# Authors' response to Referee 1

**The paper „Wind tunnel investigations of an individual pitch control strategy for wind farm power optimization“ investigates the impact of the Helix approach for wake control on the total power output of two turbines in tandem configuration as well as the effect of the Helix control on the wake development. The paper is well written and the analysis presented gives good insight in what is happening in the manipulated wake. The procedure of the Helix control and the contribution of the respective Nevertheless, there are a few points the authors should address and clarify, respectively.**

Figure 4. Schematic fast-response five-hole probe and G1 wind turbine model measurement setup for TUM-AER W/T-C

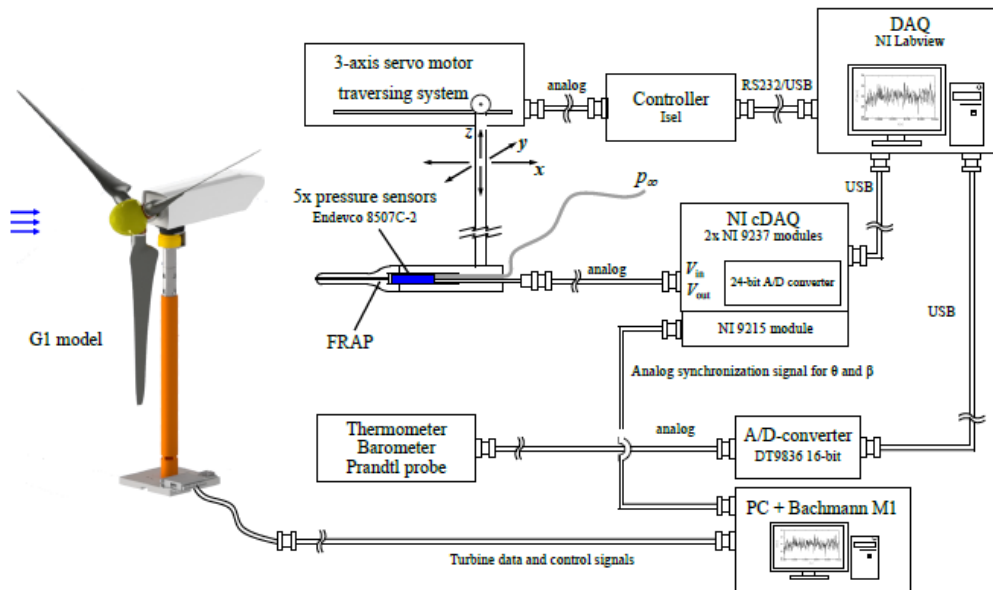
- 5) **Section 3.4 gives many details on the five hole probe and the calibration. Since these details can be found in other also mentioned publications, I recommend to leave that section out of the paper since it is not contributing to the overall story.**

Thank you for this comment. We removed this section, added the following lines in the “Measurement stages” section, and cited the respective research.

265 [The spatial and temporal characteristics and the underlying calibration process of the FRAP can be found in the literature \(see Heckmeier et al. \(2019\); Heckmeier and Breitsamter \(2020\); Heckmeier et al. \(2021\); Heckmeier \(2022\)\): A high spatial accuracy below  \$0.2^\circ\$  in both flow angles and  \$0.1 \text{ m/s}\$  in the reconstructed velocity can be achieved. The spatial and temporal](#)

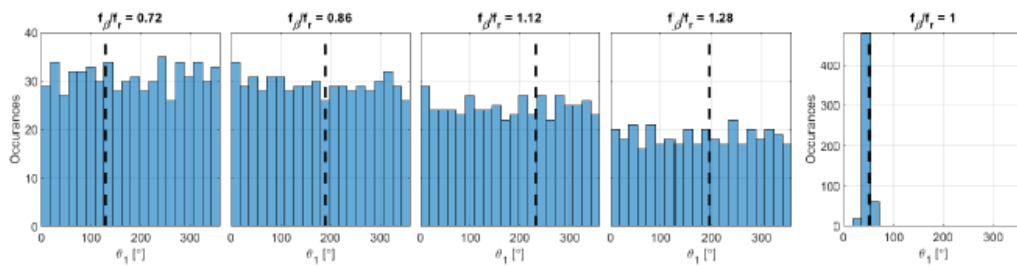
6) In figure 8, the authors observe a ditch in the thrust coefficient for  $St_{add} = 0$ . Do they have any idea where this is coming from?

Thank you for this question. The case with  $St_{add} = 0$  has been already studied in previous publications (Wang, Bottasso, & Campagnolo, 2017) (Fleming, et al., 2014). We added a paragraph in section 3.3 that quickly summarizes the results found therein, which showed poor performance of this specific implementation of the Helix, as well as its dependency on the azimuthal position of maximum pitch (something we did not investigate in our work). For these reasons, we decided not to include, in the rest of the paper, the data we gathered with  $St_{add}=0$ .

240 Different is the case with  $f_{\beta} = f_r$ ; the maximum pitch is indeed always detected at the same azimuth position, i.e. around  $\theta_{1,ini}$ . Previous experimental (Campagnolo et al., 2016) and numerical (Fleming et al., 2014) investigations found that the azimuth position of maximum pitch affects the achieved amount of wake deflection. However, the study of Wang et al. (2016) revealed that the power gains observed on the downstream machine may only be a little higher than the power losses experienced by the upstream machine, at the price of a significantly increased loading of the upstream machine. In this article, it was therefore  
 245 preferred to exclude the case  $f_{\beta} = f_r$  from the following discussions. A complete analysis would, indeed, require investigating

**Figure 8.** Normalized DELs of the upstream/actuated turbine and downstream/sensor turbine for a) rotating hub and b) fixed hub, for changing pitch frequencies  $f_\beta/f_r = (0.72 : 0.02 : 1.28)$  compared to the baseline case without any actuation  $f_\beta = 0$  (dashed line).

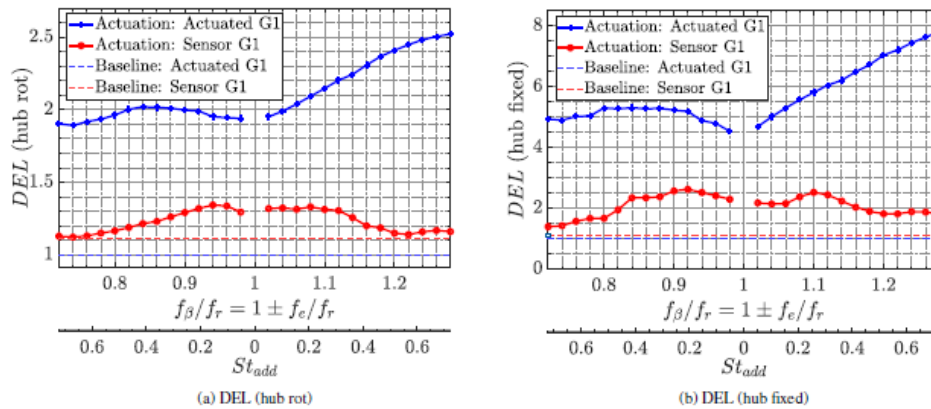
8) The presented DELs show a clear increase especially for the first turbine. Unfortunately I have not knowledge or feeling what that would mean e.g. for a real turbine. Even though the authors state in the end, that the results can not directly be applied to real turbines they should at least discuss what an increase of the DELs would have for consequences for real turbines. Would that be a total show stopper for already existing machines or would that addition be within a range that is accounted for in the current design process?

The design of most wind turbine components, such as the tower, blades, or main shaft, is mainly driven by: 1) the need to withstand the expected fatigue loads over their entire lifespan; 2) the need to withstand the ultimate loads that might act on the wind turbine even only once in its lifetime. To which extent the design is driven by the fatigue or ultimate loads, depends on the machine itself and the component under consideration. The impact of the increased fatigue loads induced by the Helix should, therefore, be assessed specifically for each machine on which it is to be implemented, and can be more or less significant depending on the role played by fatigue in the design process. We added this paragraph to the section 4.1 of the paper.

The design of most wind turbine components, such as the tower, blades, or main shaft, is mainly driven by: 1) the need to withstand the expected fatigue loads over their entire lifespan; 2) the need to withstand the ultimate loads that might act on the wind turbine even only once in its lifetime. To which extent the design is driven by the fatigue or ultimate loads, depends on the

410 machine itself and the component under consideration. The impact of the increased fatigue loads induced by the Helix should, therefore, be assessed specifically for each machine on which it is to be implemented, and can be more or less significant depending on the role played by fatigue in the design process.

Figure 11. Kinetic energy spectra  $E_{kin}$  at various measurement locations in the turbine wake at  $x/D = 0.5$  and  $y/D = \{-0.15, -0.55\}$ .

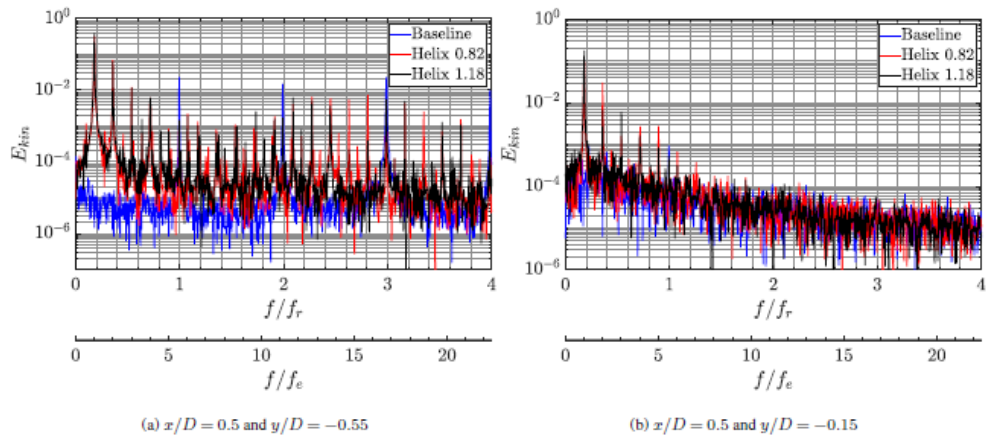
9) In the text (page 17, lower part) the authors mention four points P1 to P4 for which the spectra are presented in figure 12. Figure 12 only shows 2 points closer to the turbine  $x = 0.5D$  and not  $x = 2D$ .

10) Shifting the spectra in figure 12 vertically could help to better show the peaks for the different conditions.

Thank you for this comment. In the final version, we opted to only show the points at  $x=0.5D$ . These two points give insight in the signal content in the frequency domain, which is further described in the text. We decided not to show the farther downstream points to reduce the length of the paper. However, the other two points are covered in the dissertation of one of our authors (Florian Heckmeier, [mediaTUM - Medien- und Publikationsserver](#)). We changed the text accordingly.

Thank you for pointing this out. We adapted the y-axis range for both plots to better show the peaks:

**Figure 17.** [Schematic visualization of the process of extracting the envelope/beat frequency from the blade azimuthal and pitch position for phase-locking with the additional frequency.](#)

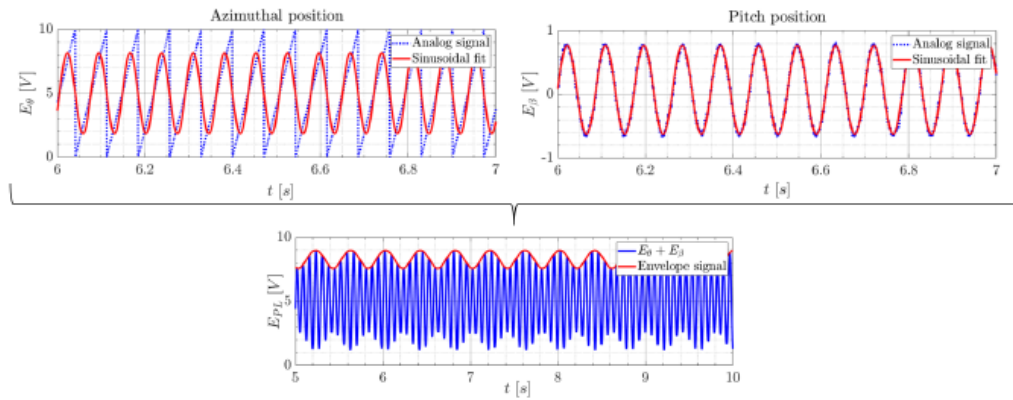
12) In section 4.2.3 the authors explain how they got the data for the phase-locked data with the additional frequency. I think it could help to show graphically how they get the beat frequency and how they apply this to the five hole data.

Thank you for this remark. We added some explanation and a figure in section 4.2.3 showing how the envelope/beat frequency signal is extracted from the blade azimuthal and pitch position.

a sinusoidal signal with  $f_e = 2.5 \text{ Hz}$  that is used in the following to phase-lock the measured FRAP data. [The process of extracting the envelope/beat frequency from the blade azimuth and pitch position is visualized in Figure 17. After extracting the time series for the beat frequency for each individual measurement point, the measured FRAP data are phase-averaged with the beat frequency. Readings of all measurement points can thereby be correlated.](#)

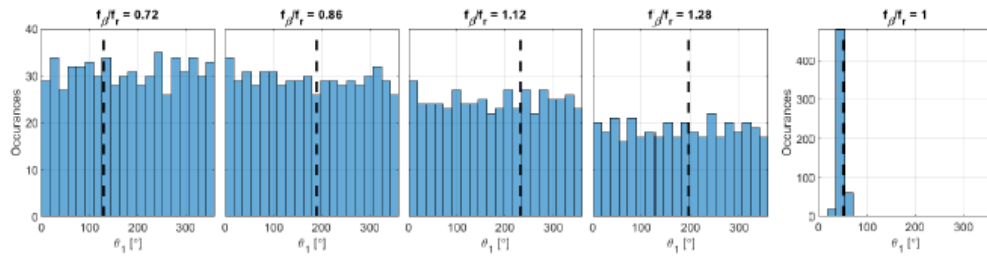
**13) For this analysis, how did you make sure that the pitching starts at the same position of the blades?**

Thank you for this question. We added a paragraph, in section 3.3, that discusses about this aspect.

230 ~~The results of these experiments~~ During each experiment, the Helix was activated a few seconds before the start of the acquisition, to allow for the downstream propagation of the new wake. The activation of the Helix, however, was not synchronized to a specific azimuth position of the rotor. For  $f_\beta \neq f_r$  this aspect is not relevant and does not affect the results. In this regard, each plot in Fig. 3 shows, for 5 of the conducted experiments, the distribution of the first blade azimuth ( $\theta_1$ ) detected when the required pitch is within the range  $0.98\beta_{\max} < \beta_1 < 1.02\beta_{\max}$ , with  $\beta_{\max} = \hat{\beta} + \beta_0 = 4^\circ + 0.4^\circ$  the maximum requested pitch angle. The dashed black line, instead, marks the azimuth position ( $\theta_{1,\text{ini}}$ ) at the very first time the required pitch is within the range  $0.98\beta_{\max} < \beta_1 < 1.02\beta_{\max}$ . For experiments conducted with  $f_\beta \neq f_r$ , the pitch is detected around  $\beta_{\max}$  for the whole range of azimuth positions (the distribution is not completely homogeneous solely due to the discrete sampling), regardless of the value of  $\theta_{1,\text{ini}}$ . This implies that the fixed-frame moments produced by the Helix rotate over the entire range of azimuth positions, which leads to the expected effects on the wake.

240 Different is the case with  $f_\beta = f_r$ : the maximum pitch is indeed always detected at the same azimuth position, i.e. around  $\theta_{1,\text{ini}}$ . Previous experimental (Campagnolo et al., 2016) and numerical (Fleming et al., 2014) investigations found that the azimuth position of maximum pitch affects the achieved amount of wake deflection. However, the study of Wang et al. (2016) revealed that the power gains observed on the downstream machine may only be a little higher than the power losses experienced by the upstream machine, at the price of a significantly increased loading of the upstream machine. In this article, it was therefore

Figure 1. Streamwise fluctuations  $u'_{rms}/U_\infty$  for the Helix 1.18 case.

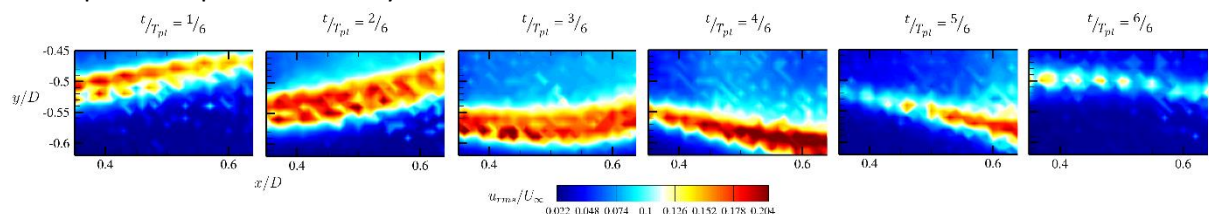
14) Is there any reason, why the authors do not perform the same analysis with the fluctuations for the phase-locked with additional frequency?

Thank you for this question. We also analysed the streamwise fluctuations  $u'_{rms}$ . However, the results of this analysis did not reveal additional information to the ones of the vorticity. As you can see in Figure 1, where the streamwise fluctuations for the Helix case 1.18 are presented, the pronounced area is slightly wider. Still, they show the same meandering as the ones of the vorticity, presented in the paper. As we did not want to further extend the size of the article, we did not consider this analysis adding new information. Consequently, we decided not to show these plots and present an analysis. We added a sentence in section 4.2.3.

Figure 2. Results from simulations for a 2-bladed rotor operated with the Helix technique for different  $St_{add}$

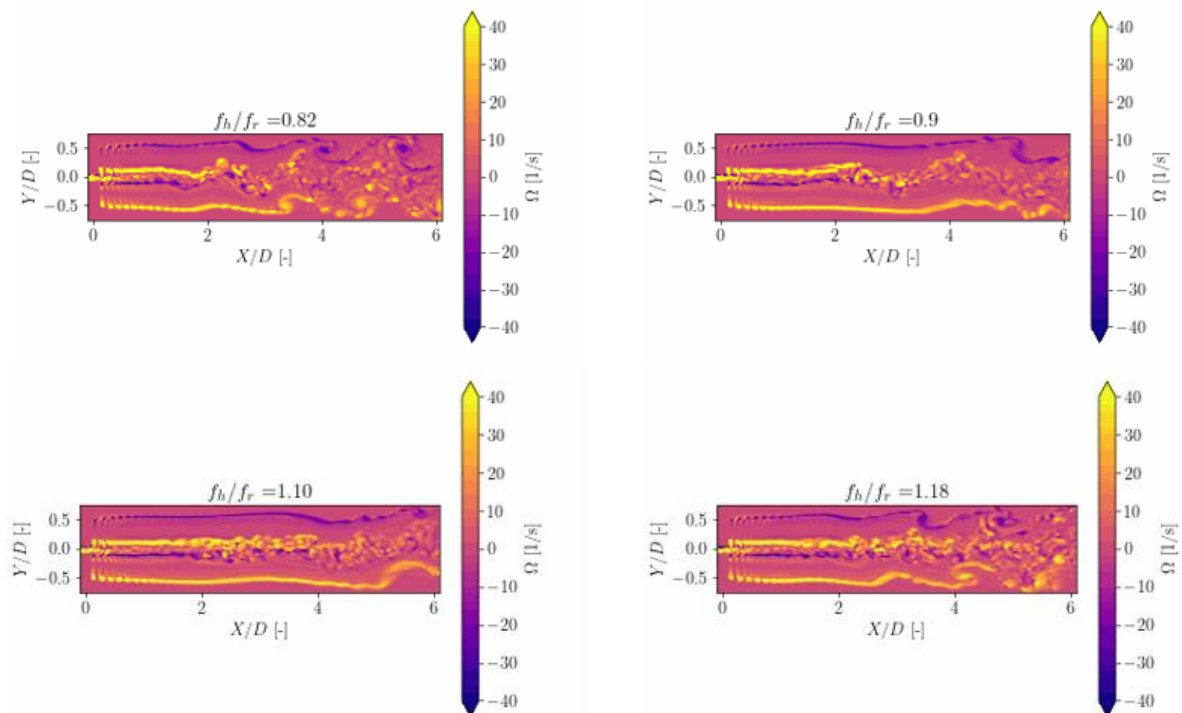
15) The authors state that the meandering of the tip vortices in the blade tip region is the main driver for the increase wake mixing. Following their analysis, I can only conclude that there is a meandering of the blade tip vortices. By performing the same analysis for other  $St_{add}$ , for which the total power is not or just slightly increased, should provide clear evidence that this meandering is either not there or decreased. The authors should add such an analysis.

Thank you for pointing out this. We agree that such an analysis would be very interesting and help clarify if the meandering is the main driver. When we conducted the experimental campaign, we decided to perform detailed wake measurements for the conditions where the highest effects on the wake were expected. By doing this, we hoped we could explain the mechanisms best. After such a study and getting more insight into the topic, having data for other frequencies would also be interesting. Unfortunately, it is impossible to perform another experimental analysis on this. Nevertheless, we are working on an article investigating the Helix technique for a 2-bladed rotor numerically. Figure 2 shows results of the wake, for different frequencies for CW and CCW rotation. For  $f_b/f_r = 0.82$  and  $f_b/f_r = 1.18$ , which are similar to the optimum cases of this article, we see significantly stronger wake meandering than  $f_b/f_r = 0.9$  and  $f_b/f_r = 1.10$ . We hope this helps to confirm our assumption and clarify your concerns. Nevertheless, as this analysis is not part of our article, we weakened the statement slightly. We wrote "...the meandering of the vortex in the blade tip region is expected to be the main driver for wake mixing..." instead of "...the meandering of the vortex in the blade tip region is the main driver for wake mixing...". Furthermore, the sentence was added to the conclusions and outlook.

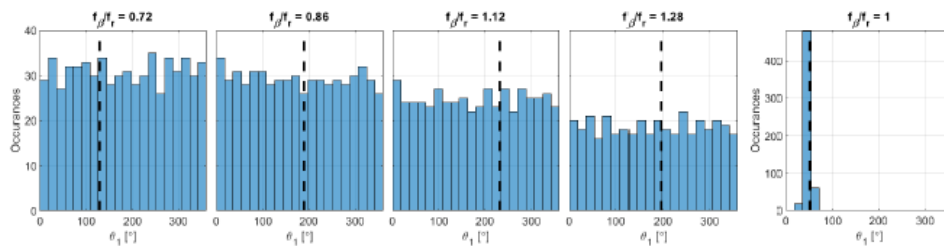
## 7) Is the blade pitch synchronized with the rotor rotation for all the cases?

Thank you for the question. No, it is not. We added a paragraph in section 3.3 that comments on this aspect and its impact on the results, which is not present.

The results of these experiments During each experiment, the Helix was activated a few seconds before the start of the acquisition, to allow for the downstream propagation of the new wake. The activation of the Helix, however, was not synchronized to a specific azimuth position of the rotor. For  $f_D \neq f_r$ , this aspect is not relevant and does not affect the results. In this regard, each plot in Fig. 3 shows, for 5 of the conducted experiments, the distribution of the first blade azimuth ( $\theta_1$ ) detected when the required pitch is within the range  $0.98\beta_{max} < \beta_1 < 1.02\beta_{max}$ , with  $\beta_{max} = \hat{\beta} + \beta_0 = 4^\circ + 0.4^\circ$  the maximum requested pitch angle. The dashed black line, instead, marks the azimuth position ( $\theta_{1,ini}$ ) at the very first time the required pitch is within the range  $0.98\beta_{max} < \beta_1 < 1.02\beta_{max}$ . For experiments conducted with  $f_D \neq f_r$ , the pitch is detected around  $\beta_{max}$  for the whole range of azimuth positions (the distribution is not completely homogeneous solely due to the discrete sampling), regardless of the value of  $\theta_{1,ini}$ . This implies that the fixed-frame moments produced by the Helix rotate over the entire range of azimuth positions, which leads to the expected effects on the wake.

Different is the case with  $f_D = f_r$ : the maximum pitch is indeed always detected at the same azimuth position, i.e. around  $\theta_{1,ini}$ . Previous experimental (Campagnolo et al., 2016) and numerical (Fleming et al., 2014) investigations found that the azimuth position of maximum pitch affects the achieved amount of wake deflection. However, the study of Wang et al. (2016) revealed that the power gains observed on the downstream machine may only be a little higher than the power losses experienced by the upstream machine, at the price of a significantly increased loading of the upstream machine. In this article, it was therefore preferred to exclude the case  $f_D = f_r$  from the following discussions. A complete analysis would, indeed, require investigating

**Figure 17.** Schematic visualization of the process of extracting the envelope/beat frequency from the blade azimuthal and pitch position for phase-locking with the additional frequency.

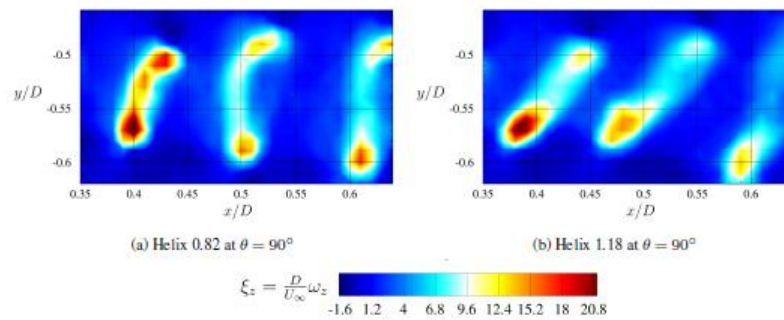
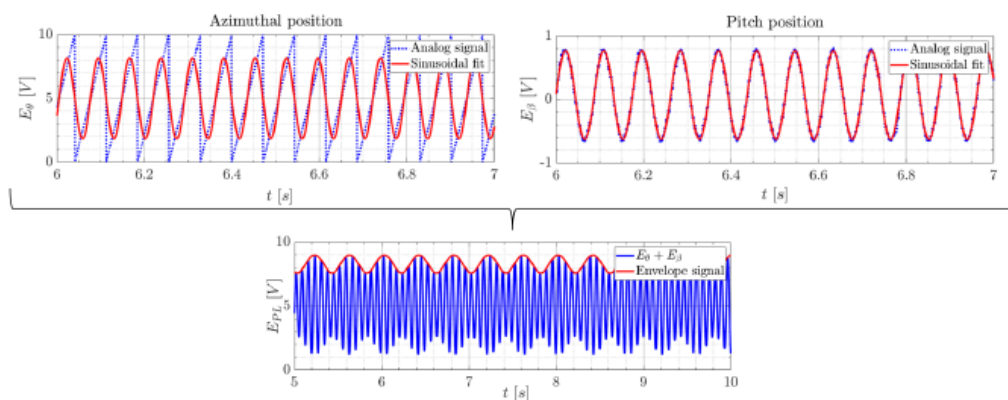
8) For phase-locked measurements, how is it ensured that during a certain azimuthal phase the pitching phase is also the same for all the cases?

Thank you for this comment. We try to clarify our approach in the following. The situation that you describe wasn't ensured during our study. We would have needed to measure the flow within the wake for several minutes, to have a sufficient amount of such events, and thus multiple exact matchings. We see the effect of this shortcoming in the Figure below, and the corresponding discussion in the text.

By applying the additional phase locking with the beat frequency, we tried to overcome this shortcoming. We added some further explanation in section 4.2.3, on how we extracted the envelope/beat frequency data (see Reviewer #1 Question 12)

Figure 4. Schematic fast-response five-hole probe and G1 wind turbine model measurement setup for TUM-AER W/T-C

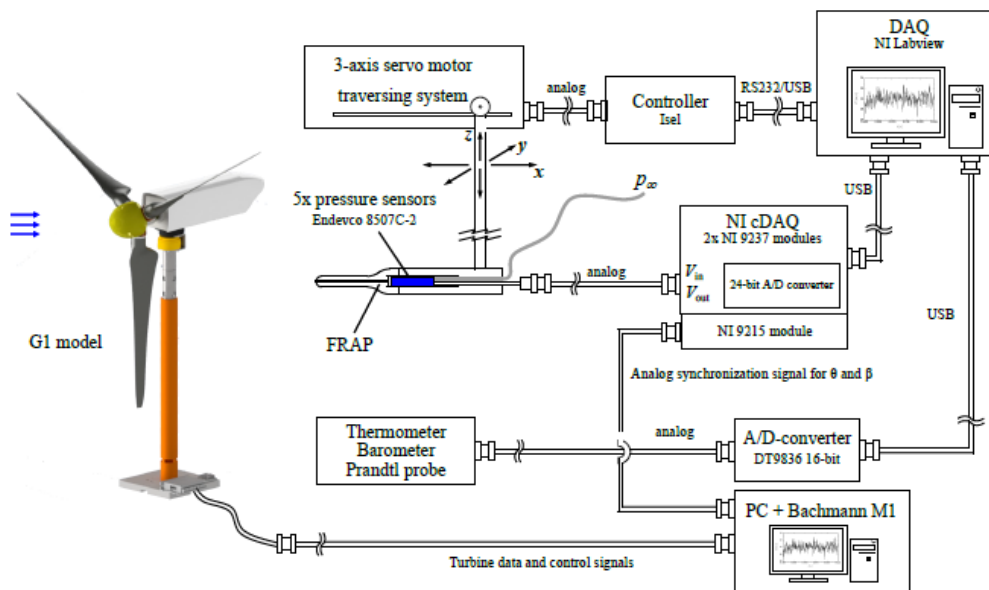
- 3) The time-resolved five-hole probe has a large head surface (around 8 squared millimeters) and therefore, for a turbulent wake in a wind tunnel, lies within the inertial range of turbulence. It is then important to check the effective temporal resolution, taking into account both background noise in the wind tunnel and spatial filtering effects. I therefore suggest that the authors show some typical spectra obtained with the probe. Also, the description of the calibration process is quite long, has it been performed by the authors or by the manufacturer? If it is the latter case, I suggest that the discussion is taken out of the manuscript.

Thank you for your comment on the probe. Since Reviewer 1 also asked for changes related to the FRAP, we changed the text. We removed the detailed section on the FRAP, despite the probe being developed and calibrated by the author in collaboration with the manufacturer (see Dissertation of F.M. Heckmeier). To answer your question on the spatial and temporal resolution of the probe, we would like to refer to a study we performed targeting this question. In this study, we addressed this topic and compared the probe to hot-wire probes using grid-generated turbulence ([\(2\) \(PDF\) Spatial and temporal resolution of a fast-response aerodynamic pressure probe in grid-generated turbulence \(researchgate.net\)](#)).

We ensured the appropriate FRAP usage and showed the probe's spatial and temporal limitations. We added this reference to the text (see also response to Reviewer 1, Question 5).

The spatial and temporal characteristics and the underlying calibration process of the FRAP can be found in the literature (see Heckmeier et al. (2019); Heckmeier and Br etsamter (2020); Heckmeier et al. (2021); Heckmeier (2022)): A high spatial accuracy below  $0.2^\circ$  in both flow angles and  $0.1\text{ m/s}$  in the reconstructed velocity can be achieved. The spatial and temporal

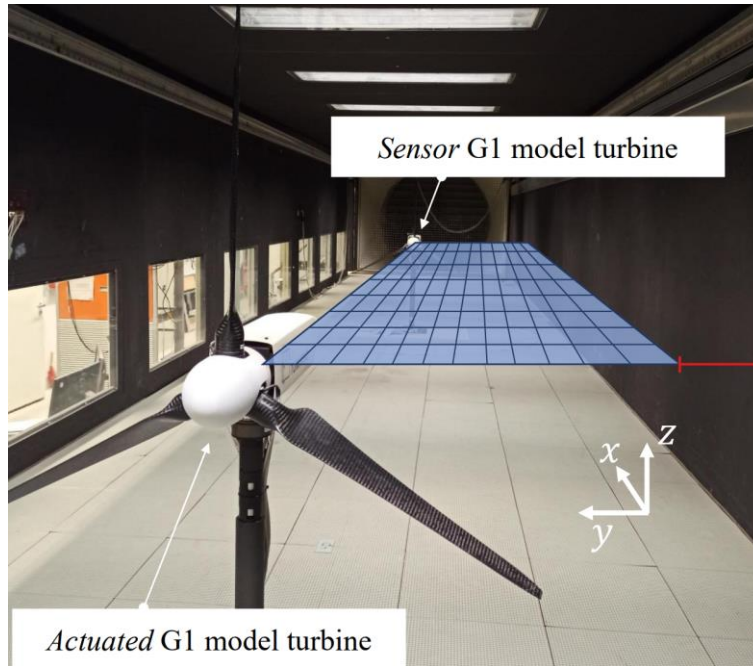
**4) Figure 10 suggests, despite the presence of an adjustable ceiling, a significant pressure gradient in the tunnel. Is that the case or an effect of the y-axis limit?**

Thank you for this question. I think this is a misunderstanding and due to the figure limits of the horizontal/y-axis. The wind tunnel has a width of 2.7m. The y-axis is limited by  $0.85D=0.935\text{m}$ . Hence, there is an additional ca. 40cm distance from the measurement location to the wind tunnel wall (see the red line in the figure below). We hope this clarifies your question.
